**TOWN OF NEWBURGH
PLANNING BOARD
TECHNICAL REVIEW COMMENTS**

PROJECT NAME: DOLLAR GENERAL -ROUTE 52
PROJECT NO.: 23-25
PROJECT LOCATION: SECTION 60, BLOCK 2, LOT 65
REVIEW DATE: 31 MAY 2024
MEETING DATE: 6 JUNE 2024
PROJECT REPRESENTATIVE: MECURIO-NORTON TAROLLI-MARSHALL- ENGINEERING & LAND SURVEYING

Re: Job No. 4980
Tax Parcel: 60-2-65
NYS Route 52
Town of Newburgh
Orange County
Dollar General Site Plan
Town of Newburgh Project No.: 2023-25

**RE: Review Comments for Dollar General, 242 South Plank Rd (NY-52), Town of Newburgh, NY;
CM Project #123-001.14, Town Project #23-24**

Site Plan for Dollar General

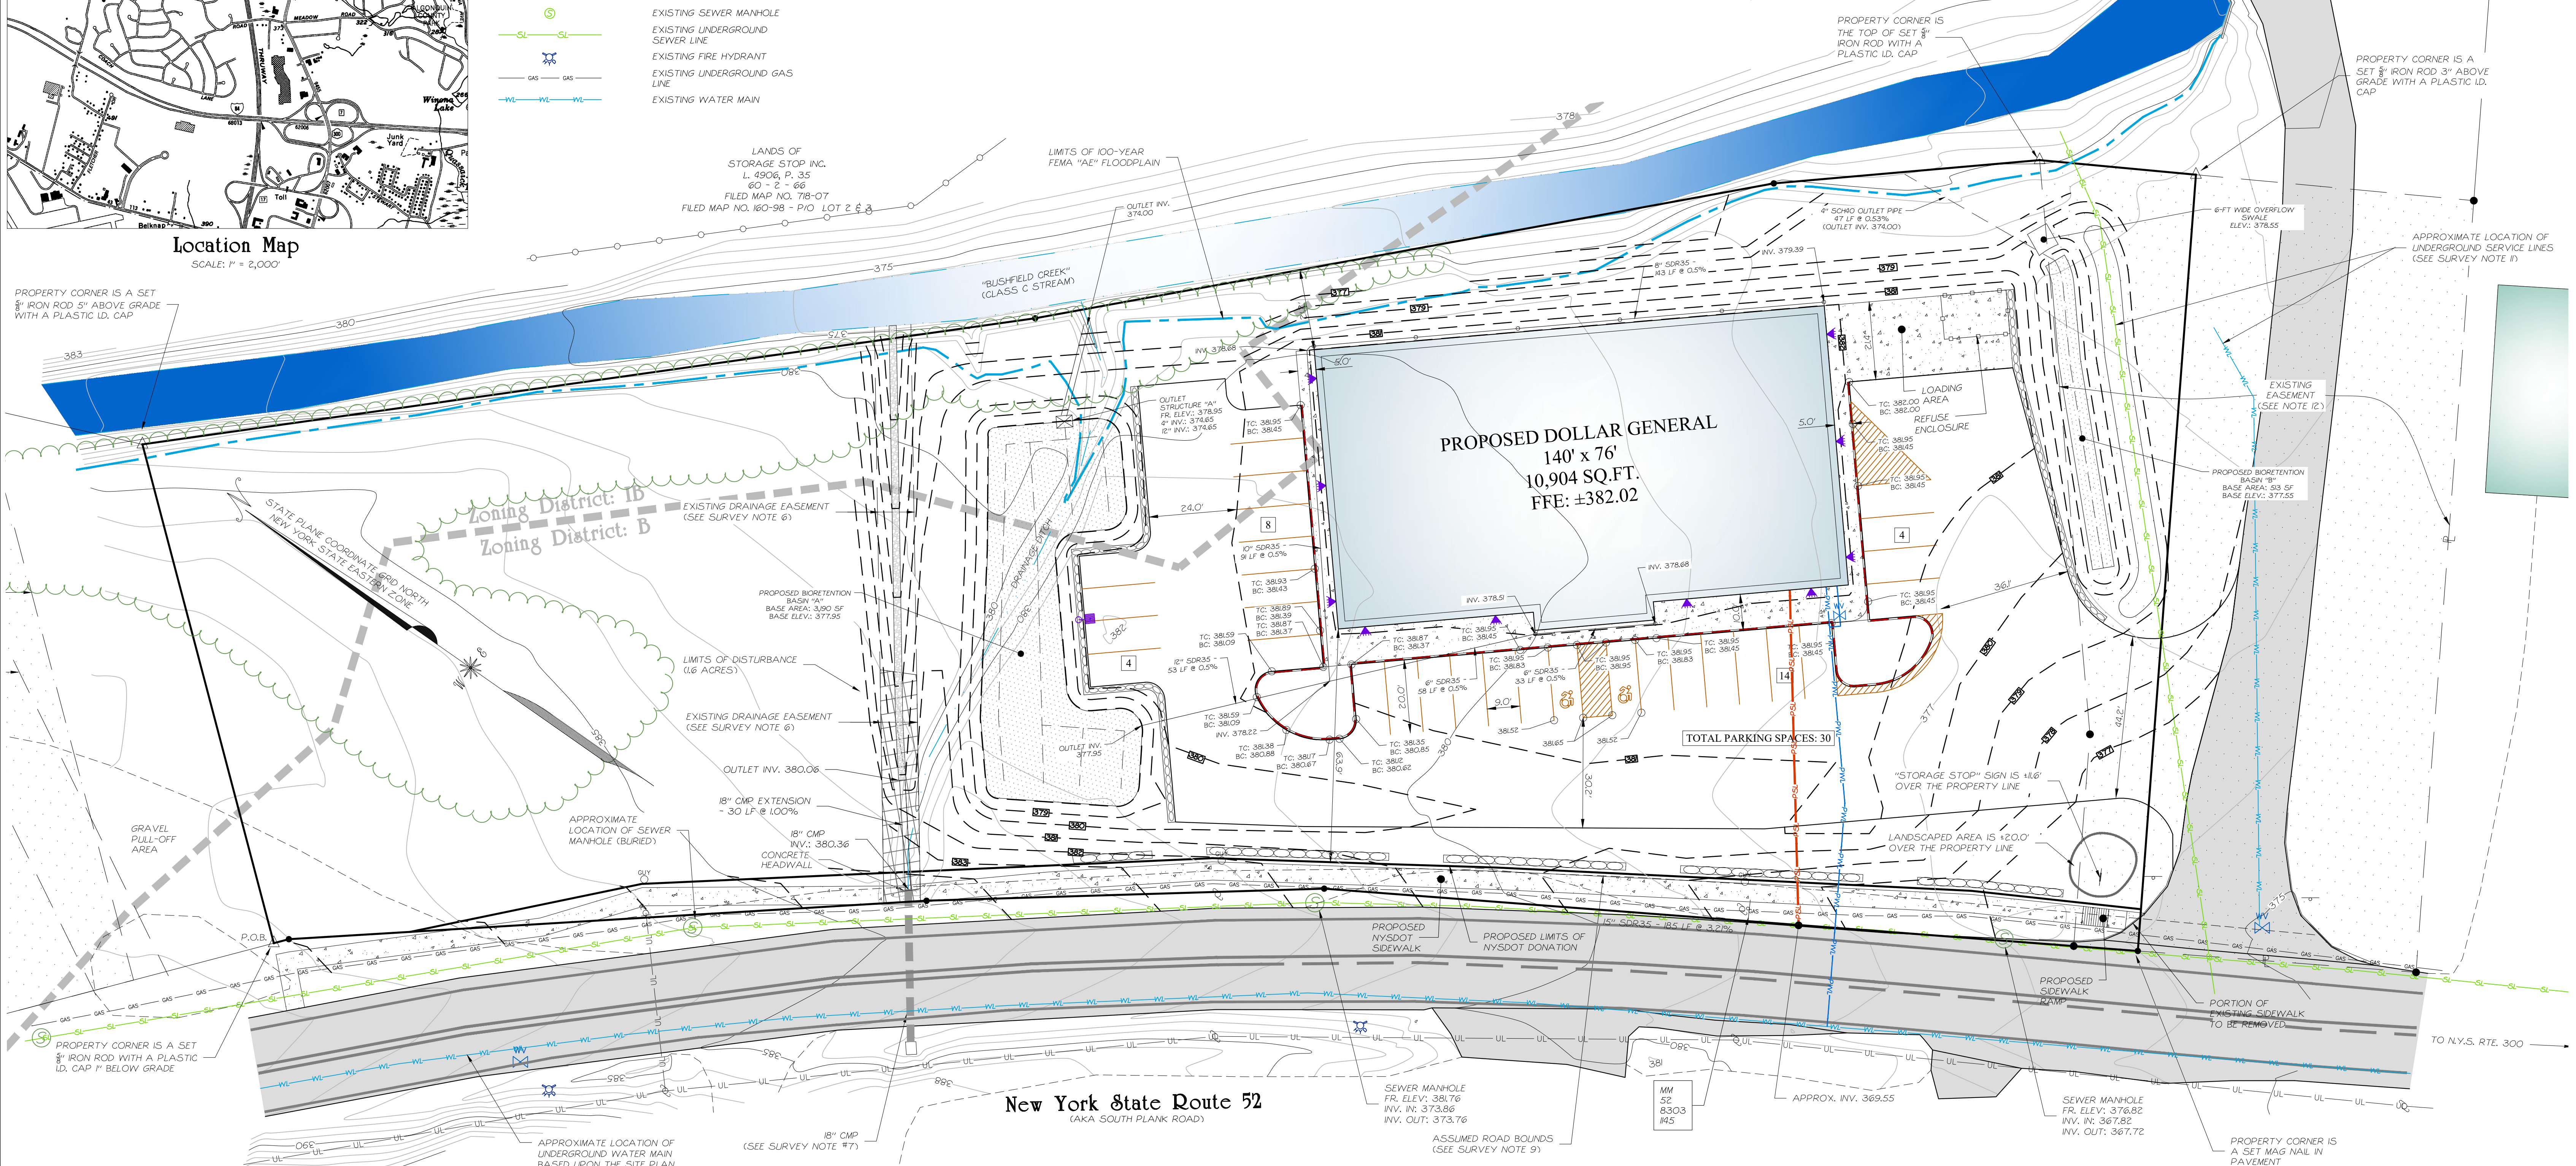
1. Status of the NYSDOT review of the project should be received. A land donation is proposed to NYSDOT to allow installation of the sidewalk within the DOT right-of-way. Detectable warning should be added to the sidewalk termination at the northwestern portion of the site.

6. The current site plan proposes a sidewalk across the entire project frontage; it should tie back to the shoulder of Route 52 at the north end and connect to the main driveway with a ramp at the south end. Consider a sidewalk connection and crosswalk perpendicular from the Route 52 sidewalk to the main entrance.

1. Comment responded to in letter from Stephan A. Maffia, P.E.
2. Comment responded to in letter from Stephan A. Maffia, P.E.
3. Comment responded to in letter from Stephan A. Maffia, P.E.
4. Comment responded to in letter from Stephan A. Maffia, P.E.
5. Comment responded to in letter from Stephan A. Maffia, P.E.
6. The sidewalk on the north end has been revised to connect to the edge of the existing pavement on NYS Route 52. The sidewalk on the south end has been revised to include a sidewalk ramp.

Bioretention Area Detail

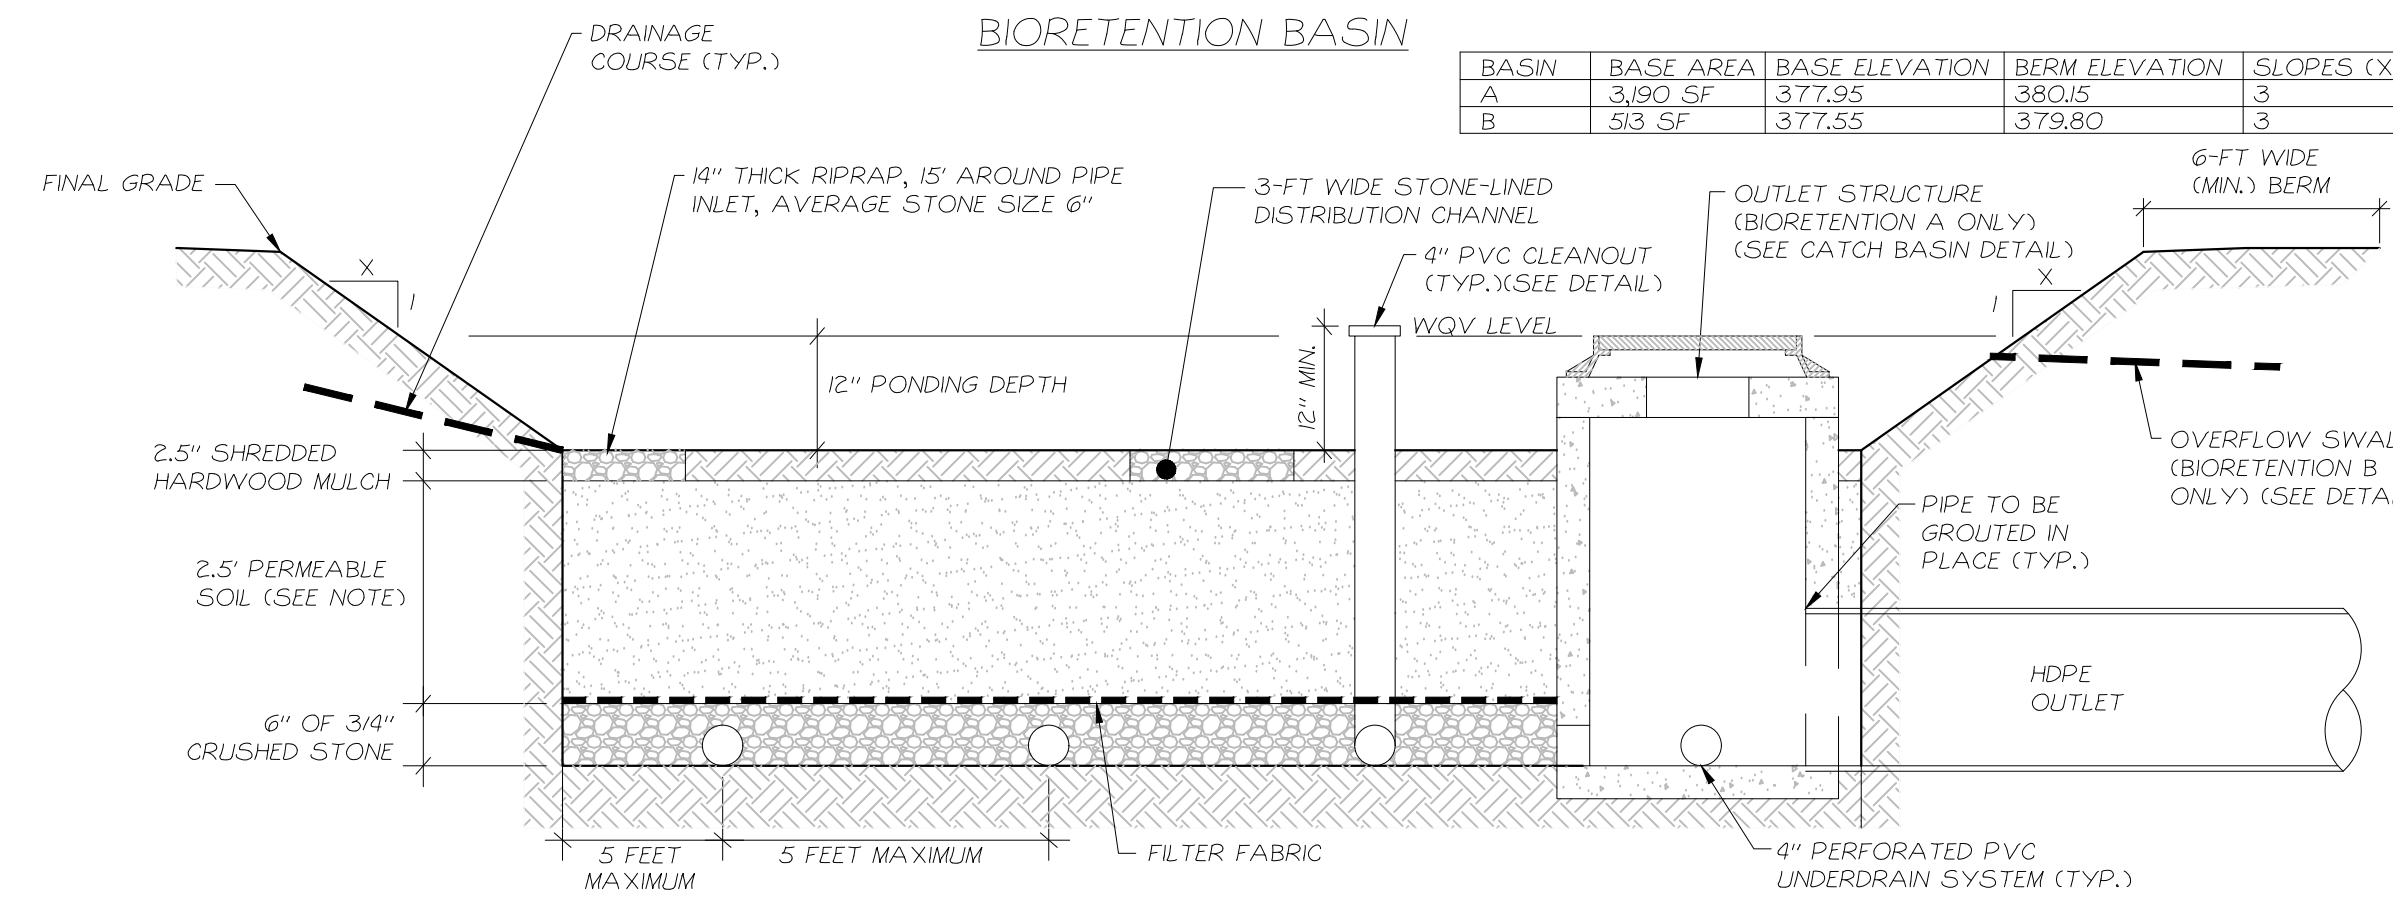
3. A Flood Plain Development Permit is required to be received from the Town Building Department.
4. The stormwater landscaping note on Sheet 6 of 11 appears to conflict with the bio-retention details and Landscaping Plan. The northerly most bio-retention area is proposed to have a mulch surface, not seeded.

Decorative Stonewall Detail

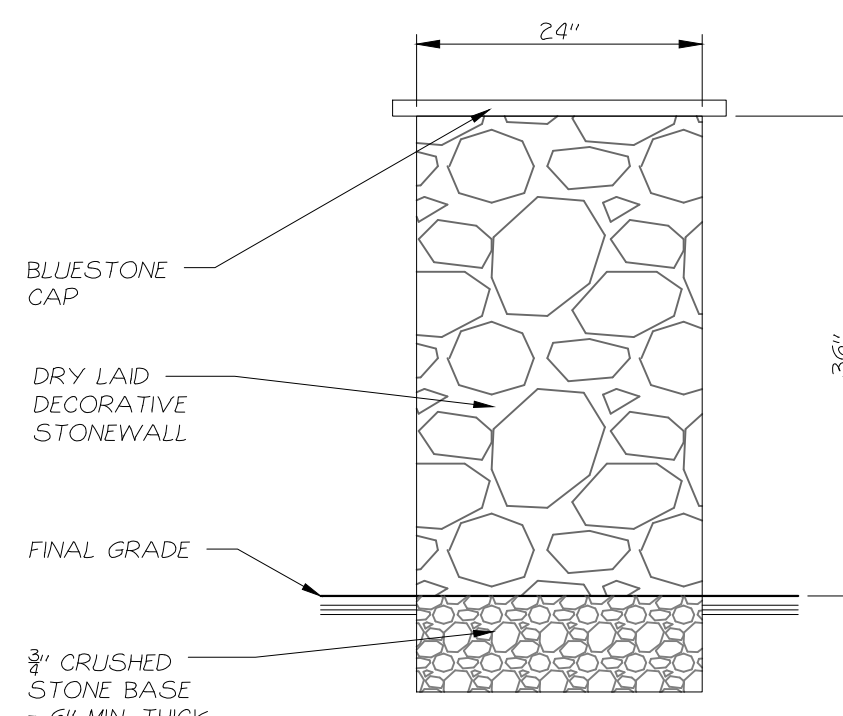
6. A decorative dry laid stone wall has been proposed along the property frontage. The stone wall contains breaks which are landscaped.
7. Drainage is designed to sheet flow from the site into the stormwater management practices. Curbing is not proposed on the outer perimeters of the site to allow the sheet flow drainage. Based on elevations on the site and the water course along the eastern property line. Curbs and closed pipe drainage will not function.
